CycleWR is pleased to see the Region implementing a pilot program to test various options for improving cyclist and pedestrian safety at the Region's roundabouts. We think that both ideas (raised crossings and push button warning lights) would improve safety at all of the current roundabouts in the Region.

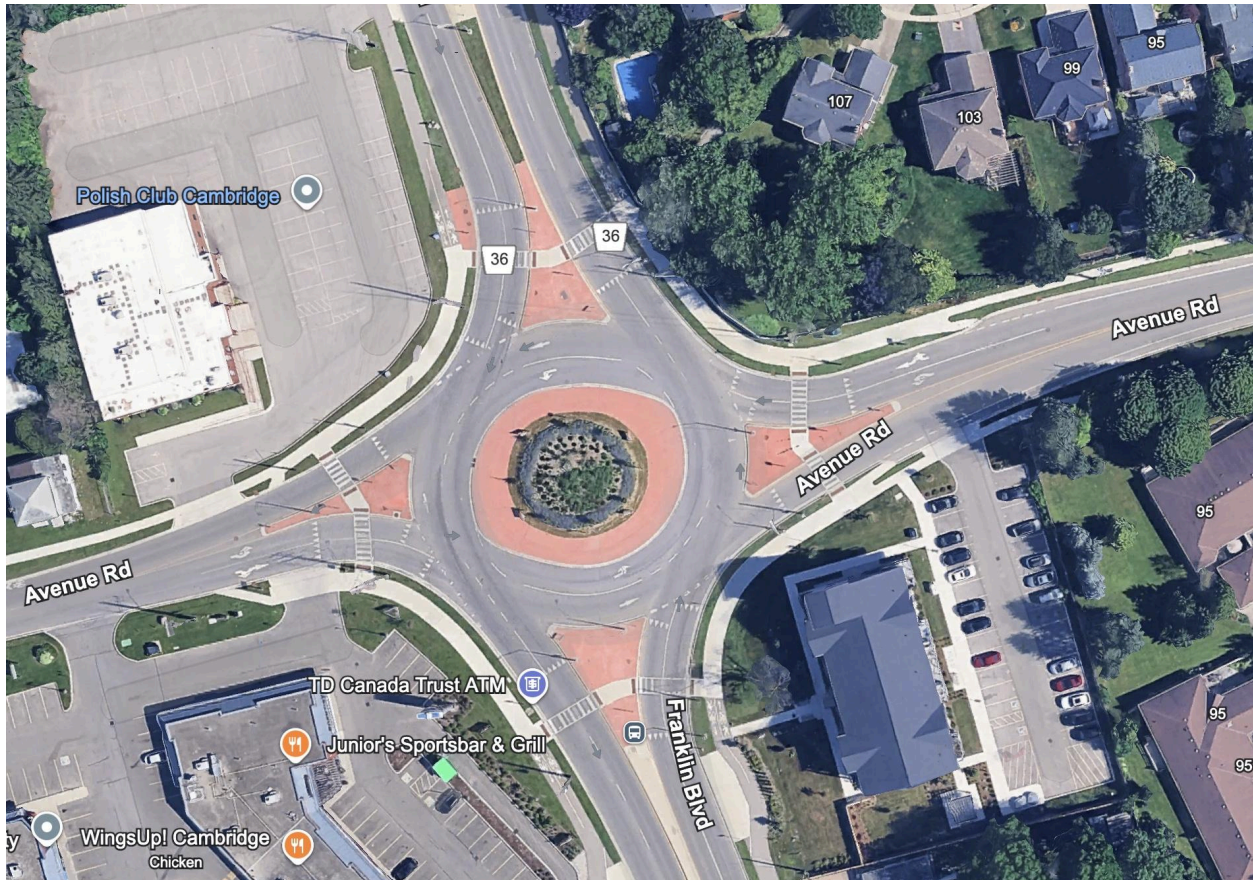
6. Roundabouts should be designed with the minimum number of lanes that will handle the expected traffic. Projections that assume traffic will increase in line with targeted population growth should also assume reduction in traffic due to targeted modal share shift.

Tangential Roundabout Design

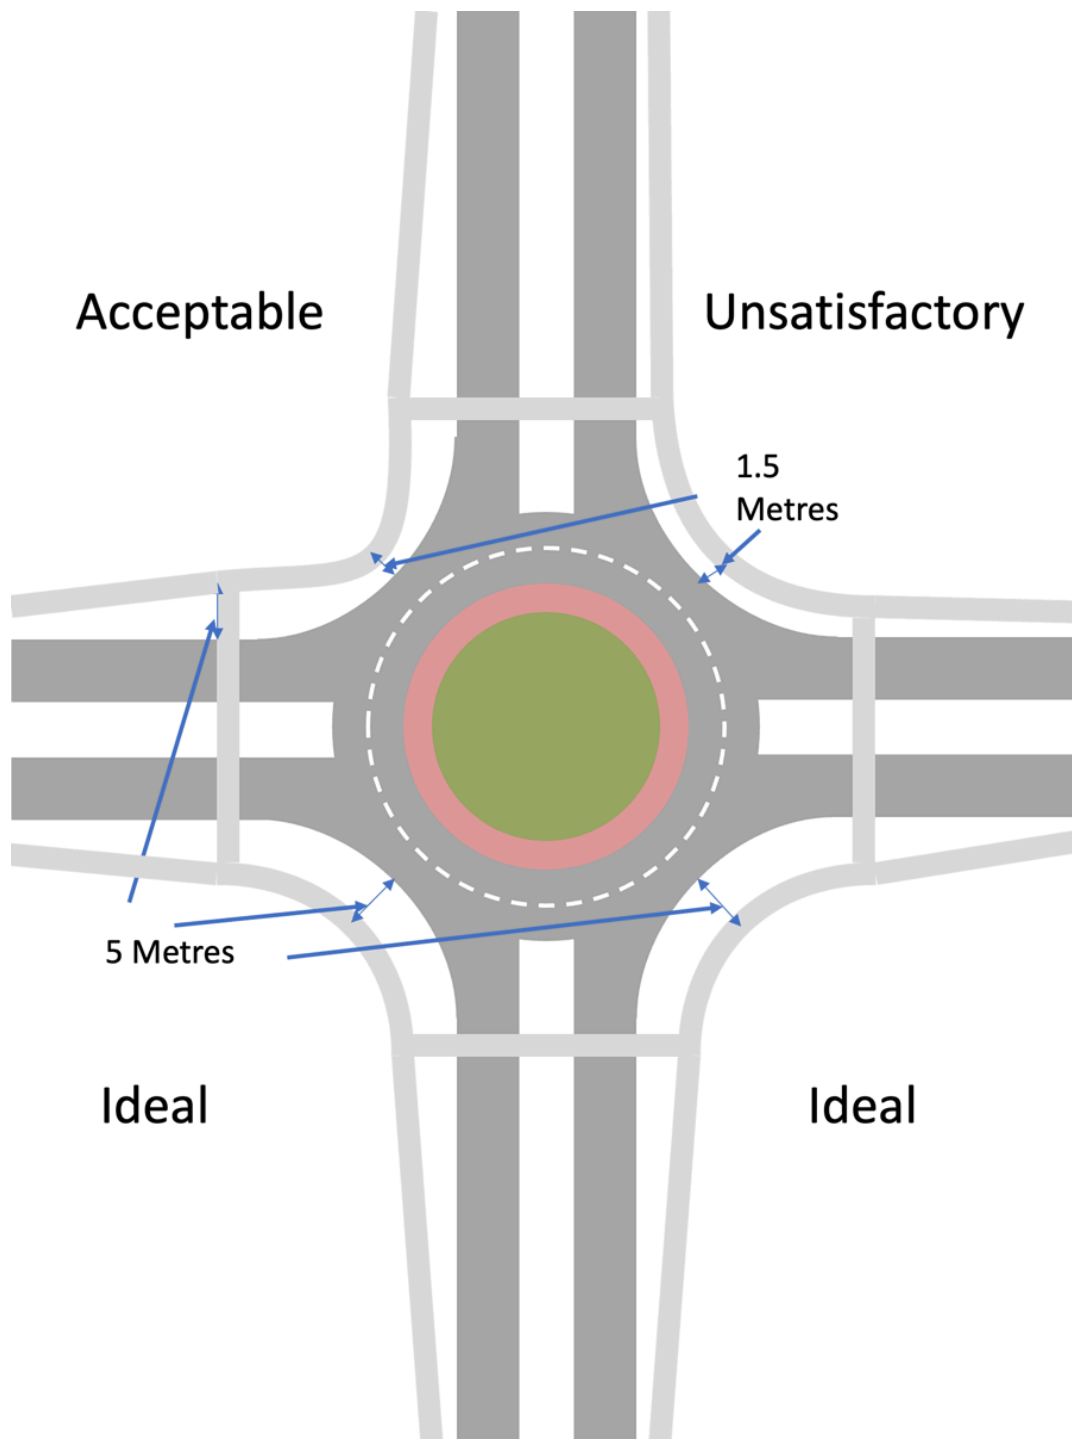
4. Radial designs (as in The Netherlands and some other European countries) should be the default design. They have sharper turns when entering and exiting the roundabout circle, forcing cars to slow down. The exits in the Region's standard tangential design are especially unsafe for cyclists and pedestrians. They are almost a straight line, allowing much faster exit speeds. See the picture and graphic at the bottom of this document.

10. Standard roundabout design should maximize sightlines for both drivers and cyclists. Drivers should have as long a lead time as possible to realize that a cyclist is definitely planning to cross the roadway in front of them. Today, the definitive turn to cross the roadway (rather than carry on straight) typically happens only 1-2 metres from the roadway. That distance should be 5 metres or even more wherever space allows that separation. If necessary, the cycling facility could bend away from the roadway just before the turn. This creates more space at the turning point, while minimizing the space required around the rest of the roundabout. See the picture and graphic at the end of this document.
